# CITY PLANNING COMMISSION

**APPLICATION:** A. Negative Declaration

B. Special Permit to expand a church facility and establish a master plan for church facility on 3+ acres in the Agriculture (A) zone.

**APPLC. NO.** P86-133 **MEETING DATE** May 8, 1986 **ITEM NO** 12

## PHASE 1 MASTERPLAN

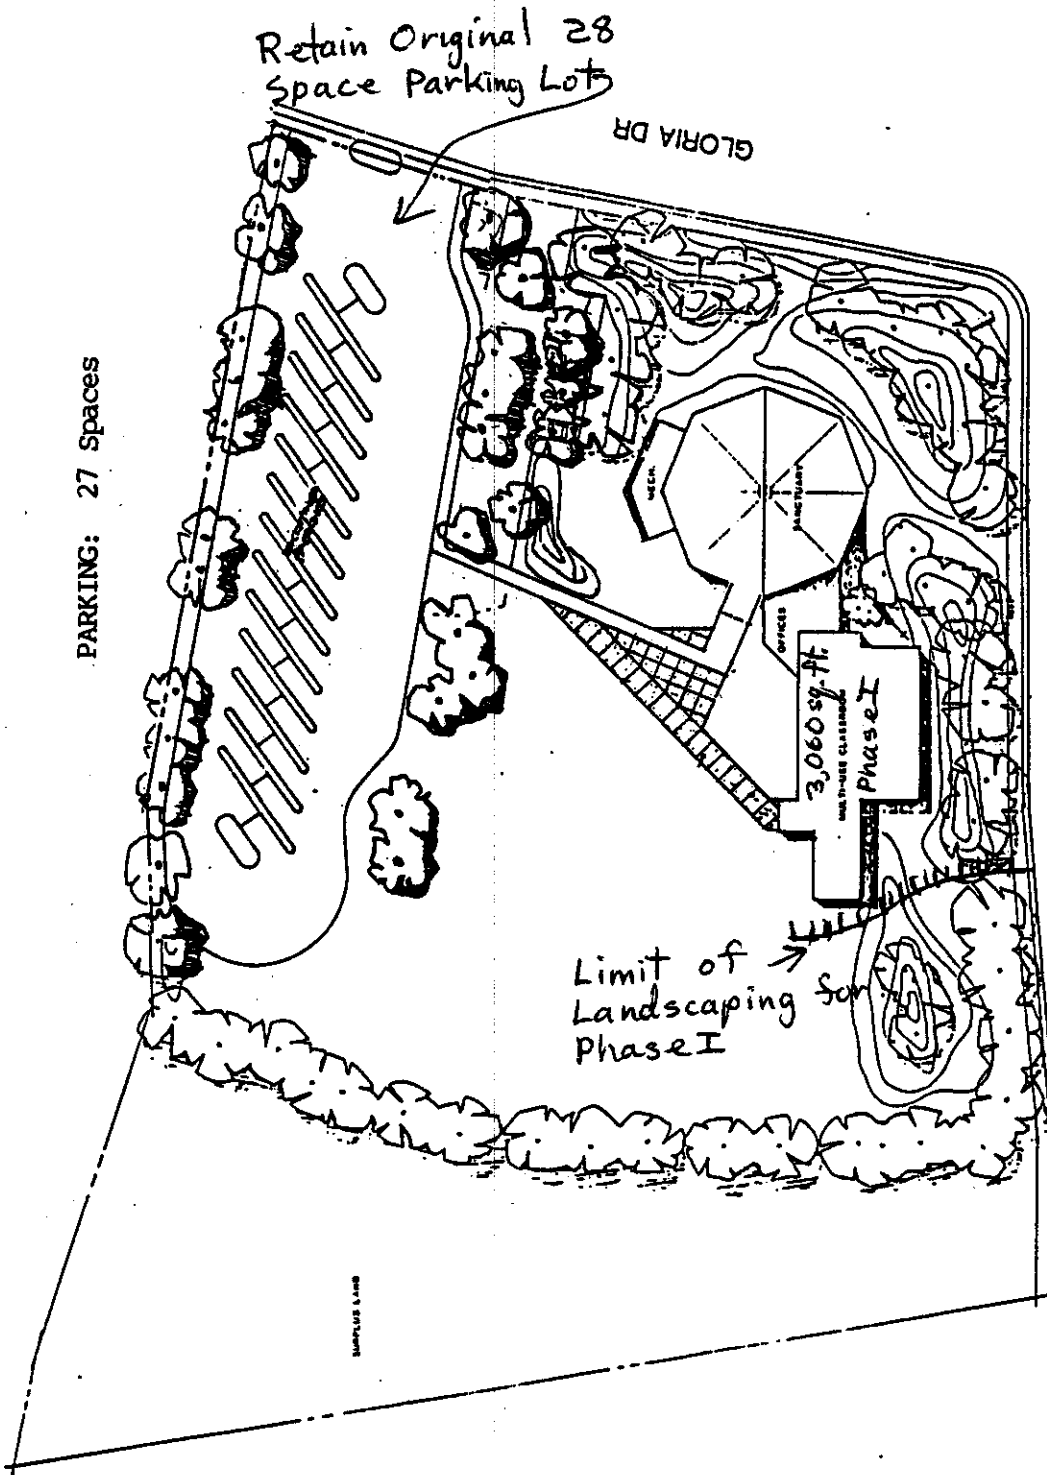
C. PHASE I

1. Building: Construct a 3,060 square foot multi-use classroom.
- a. Contains six classrooms
  - b. Kitchen area of 140 square feet
  - c. Bathroom facilities
  - d. Office area of 120 square feet
  - e. Movable walls will allow 120-seat dining room (20 parking spaces)

The applicant is not planning on establishing a pre-school at this time. A subsequent special permit will be necessary for a pre-school. No changes are proposed in the design of the parking lot for Phase I. The only landscaping improvements will be for the area between the multi-use classroom and Florin Road.

3. Wall or Fence Requirement: The City code requires a solid masonry wall whenever a non-residential use, in this case a parking lot, is adjacent to a residential zone or use.

The single family residentially zoned property located to the east of the site has a six-foot high solid board fence in good repair and heavily landscaped. No improvements to the parking lot are planned for Phase I, so the issue of a wall does not need to be addressed for Phase I. The applicant does plan on expanding the parking lot when Phase II is started. At that time, the issue of the wall on the east property line will be resolved.

Landscaping: A concrete walkway is proposed to the multi-purpose building from the parking lot. Landscaping will be included in the final site plan for Phase I. Staff recommends that detailed landscaping and irrigation plans be reviewed by staff prior to issuance of building permits which would show the following:

- a. Berming of three to four feet height along Florin Road frontage the length of the new building 116 feet is proposed. The remaining 112 feet to the north property line does not need to be landscaped since the Phase IV classroom building is planned for the northern lot area. The applicant has indicated limited resources to install all landscaping along Florin Road as part of Phase I.

- b. Heavy tree coverage is recommended along Florin Road. Use of evergreen trees, such as redwood or continuance of eucalyptus presently used on the site is suggested. Trees should be a minimum five-gallon size and planted on 20-foot centers or clustered at a similar density. Shrubs should be planted adjacent to the building. All landscaped areas should be lawn and irrigated. The remaining undeveloped areas of the lot is to be cleared and kept in a non-hazardous condition so that grass fires will not occur nor trash accumulate. Staff prefers irrigation and installation of grass on the remaining vacant portion but realizes the increased maintenance cost may preclude the improvement. The applicant has indicated that as Phase II, III and IV are built, more areas will be landscaped and irrigated.

1. The colors and materials used on the multi-purpose building of Phase I shall be compatible and similar to the existing sanctuary building. All subsequent phases shall maintain the architectural and design similarity.
2. The applicant shall install a six-foot solid decorative masonry wall at the time of the Phase II parking lot expansion or obtain the necessary waiver from the Planning Commission.
3. The applicant shall submit detailed landscaping and irrigation plans which show the following:
  - a. Landscaping and irrigation system;
  - b. For Phase I, a three to four-foot high landscaped berm along Florin Road frontage.

Heavy tree coverage with evergreen trees, (five-gallon size). Staff recommends redwood trees, or trees selected based on input from the City Arborist. Trees shall be a minimum of 20 feet on center or clustered in a similar density of one tree for every 20 feet of street frontage;

- c. Shrubs are to be placed adjacent to the west wall of the multi-purpose building;
  - d. Remaining undeveloped areas shall be maintained in a weed free non-hazardous condition.

NORTH ELEVATION  
SCALE 1/8" = 1'-0"

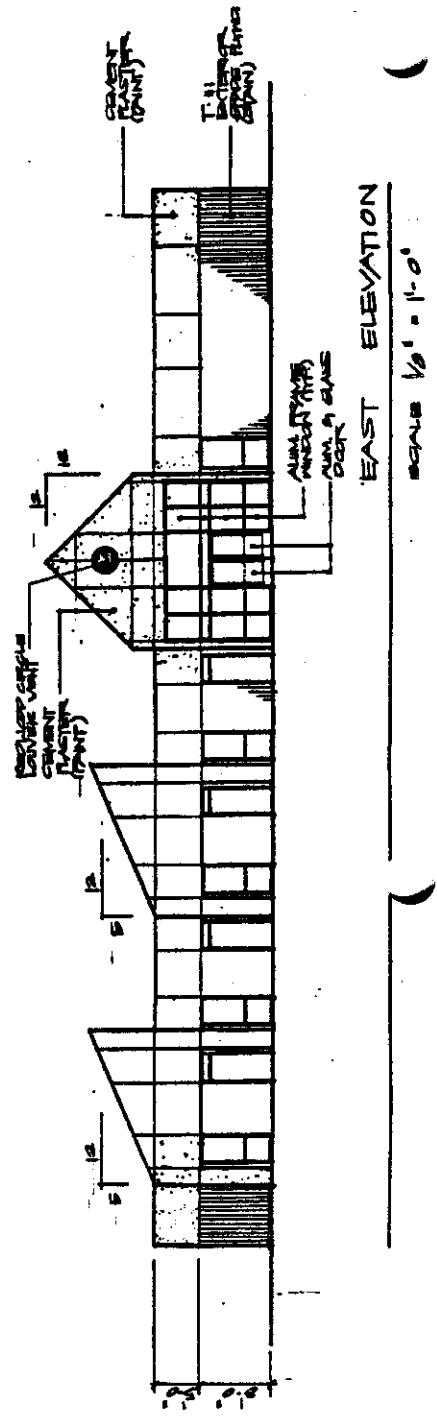
2. Elevations: The proposed Phase I multi-purpose building will be a one story wood frame construction with plywood siding, T1-11 and cement plaster paint. Plywood siding will be stained to match the existing church. Doors and windows will be aluminum frame. Roof material will be composition asphalt shingles, a color similar to the sanctuary building. The roof line has angular projections visible from Florin Road. Staff supports the elevations as long as the colors and materials are uniform with the sanctuary and additional buildings.

## PHASE 2 MASTERPLAN

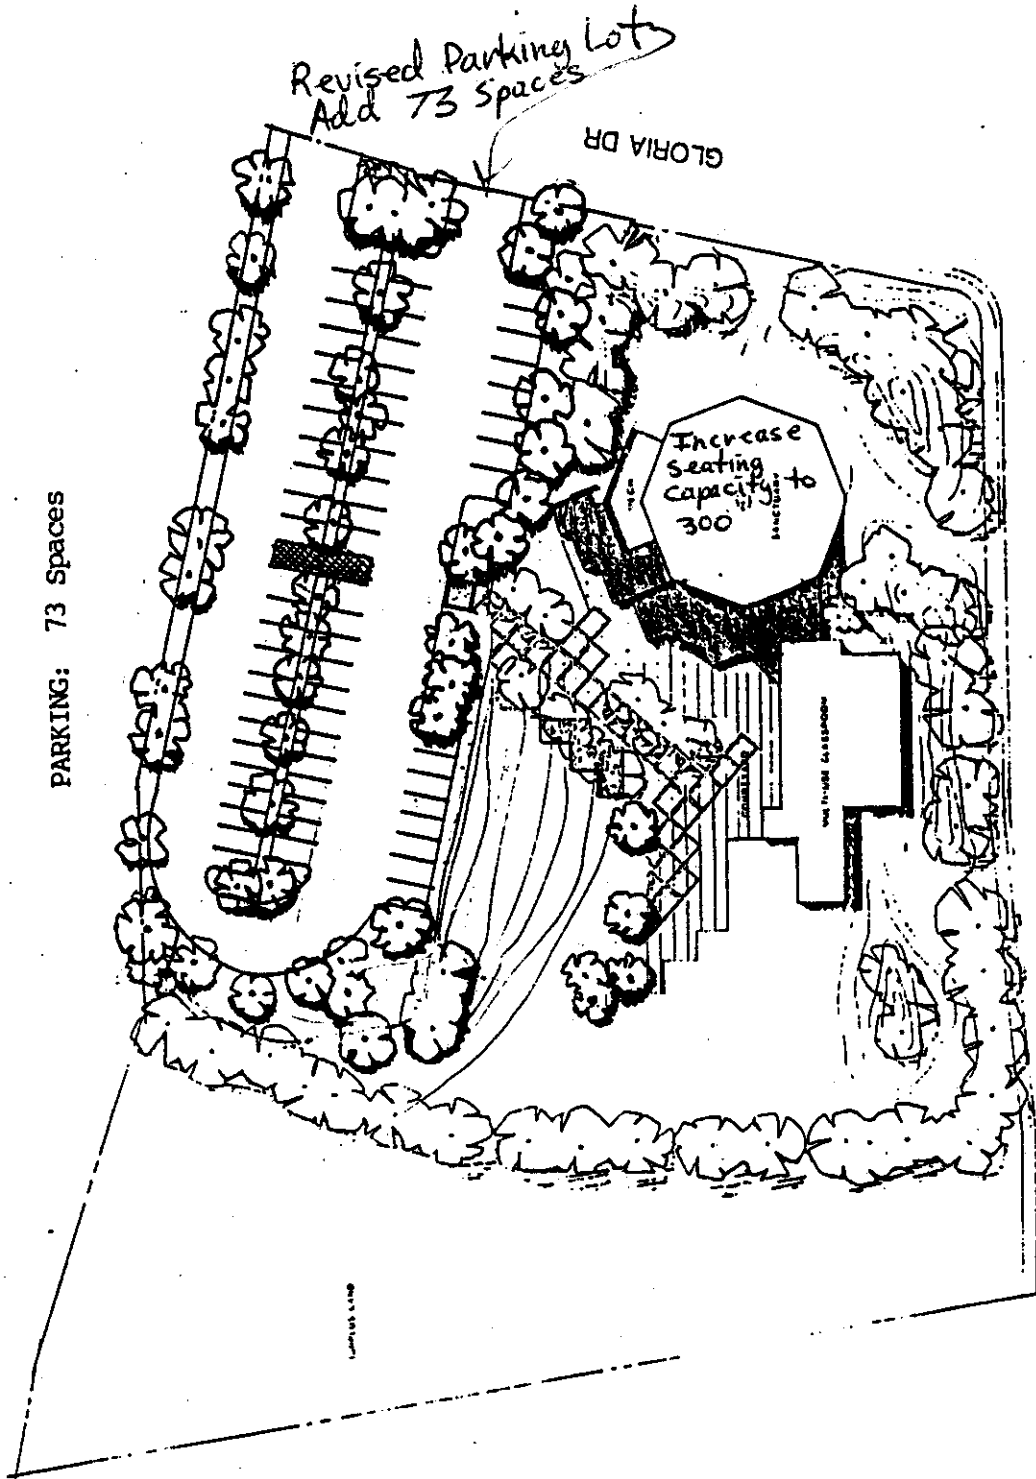
D. PHASE II

- a. Construct church offices - 600 square feet
- b. Enlarge Narthex - 806 square feet
- c. Add outdoor storage area
- d. Refurbish sanctuary to increase seating capacity to 300
- e. Expanding parking lot to 73 spaces

2. Elevations: No elevations were provided. Staff recommends that exterior building elevations be reviewed by the Planning Director for architectural compatibility with the Phase I building. No elevations were provided for Phase III or Phase IV so that staff review of elevations for consistency is recommended as a condition of this special permit.

3. Site Plan: Additional seating capacity of the church will not require exterior changes to the sanctuary. The addition of the narthex and offices will be on the side of the sanctuary facing the east parking lot area. The precise parking lot plan should show compliance with the parking ordinance, including the 50% tree shading requirement. Staff recommends that precise parking lot and space dimensions be shown on the revised site plan for Phase II.

4. Fence or wall requirement: At the time the parking lot is expanded, either a six-foot solid masonry wall will be required, or a variance application must be submitted to the Planning Commission for consideration. This special permit does not waive the requirement of a six-foot solid masonry wall.
5. Landscaping: The parking lot will be landscaped. Detailed plans will be required for materials and ground coverage. Staff recommends that all landscaping be phased for subsequent expansion.

5. The applicant shall submit to the Planning Director for review and approval revised site plans and elevations for Phases II and III prior to issuance of building permits.

6. The revised parking lot shall comply with the City Parking Ordinance for aisle width, stall dimension and maneuvering area. The lot shall be shaded in accordance with the tree shading ordinance.

## PHASE 3 MASTERPLAN

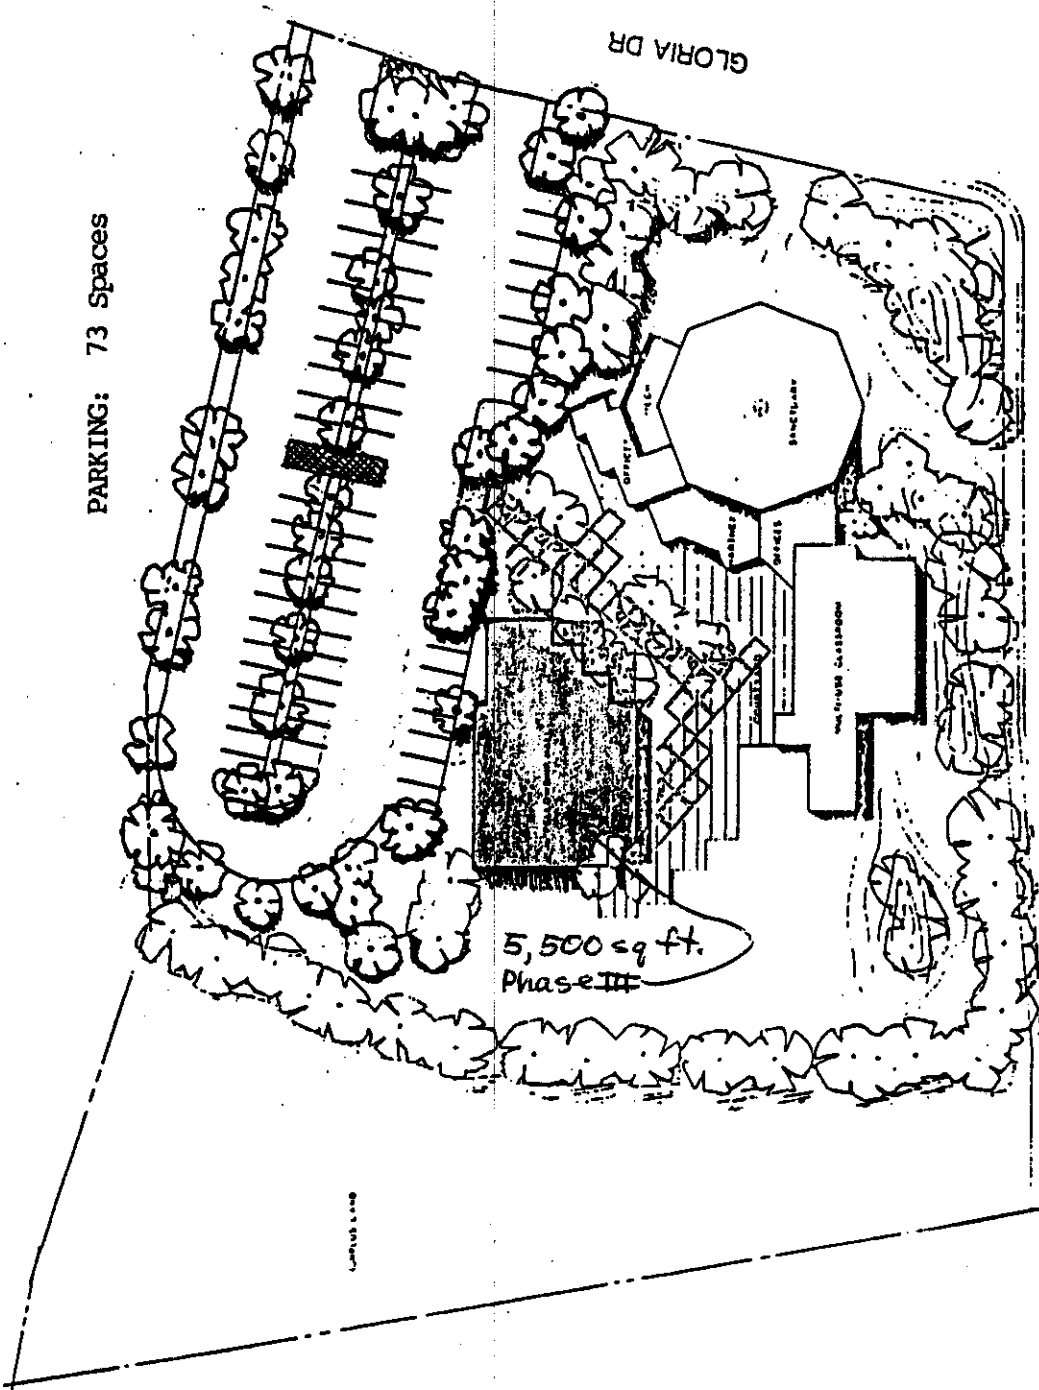
E. PHASE III

The applicant proposes to construct a 5,500 square foot fellowship hall with a seating capacity of 350 persons and a kitchen facility. This building will be located adjacent to the expanded parking lot.

Since no elevations or floor plans were submitted, staff recommends that exterior building elevations, floor plans and landscape plans shall be reviewed and approved by the Planning Director prior to issuance of building permits for the Phase III building.

The new fellowship hall could create additional parking demand. However, the applicant has indicated that the use of the sanctuary, fellowship hall and multi-use classroom at the same time will not happen. In order to evaluate and determine whether the Phase III building (fellowship hall) could create additional parking demand, staff suggests that a new special permit-public hearing be required for Phase IV expansion. Additional parking could therefore be required as part of Phase IV expansion.

PHASE 4  
**MASTERPLAN**  
nto, Ca  
Reynolds, Webber Architects Sac

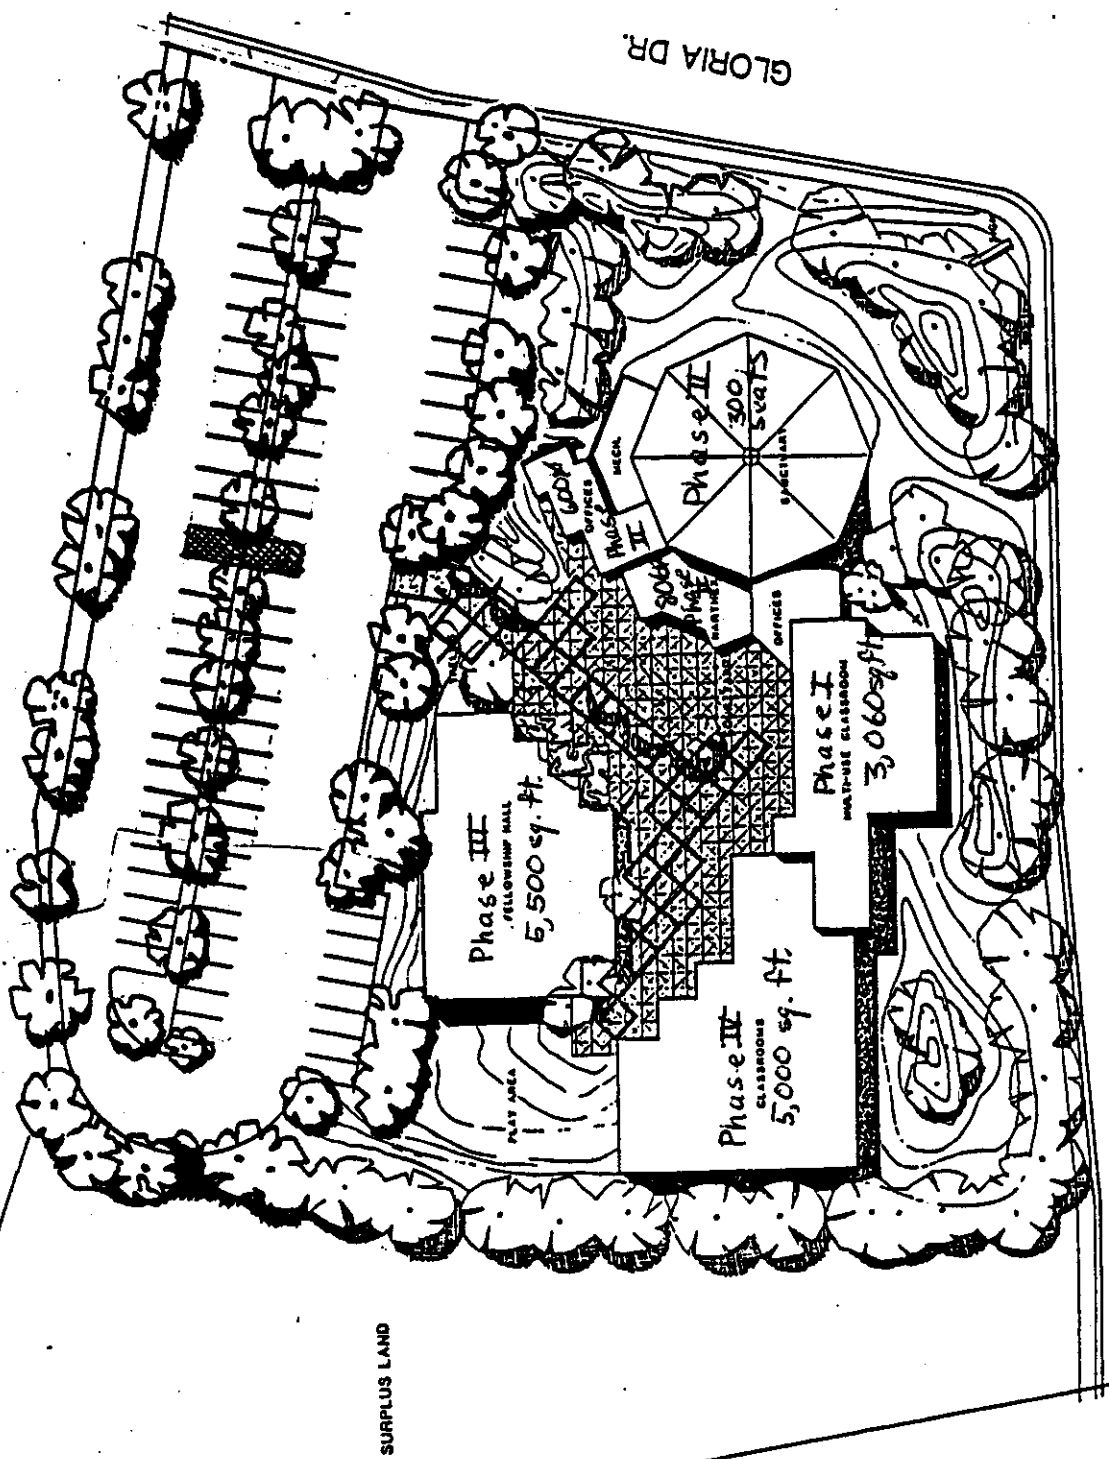
F. PHASE IV:

The applicant proposes to construct a 5,000 square foot classroom building with 18 classrooms and bathroom facilities. This Phase IV building will be located on the northerly portion of the site and adjacent to the proposed Phase I building. (See Phase IV site plan.) No elevations were provided at this time.

A new special permit and public hearing should be required so that staff can evaluate the parking demand for the Phase III (fellowship hall) and the potential parking demand of the Phase IV building expansion. Additional parking could be required at that time.

7. A new special permit for Phase IV shall be required.
  8. All on-site lighting shall be directed onto the subject site and not reflect onto adjacent residentially zoned property.
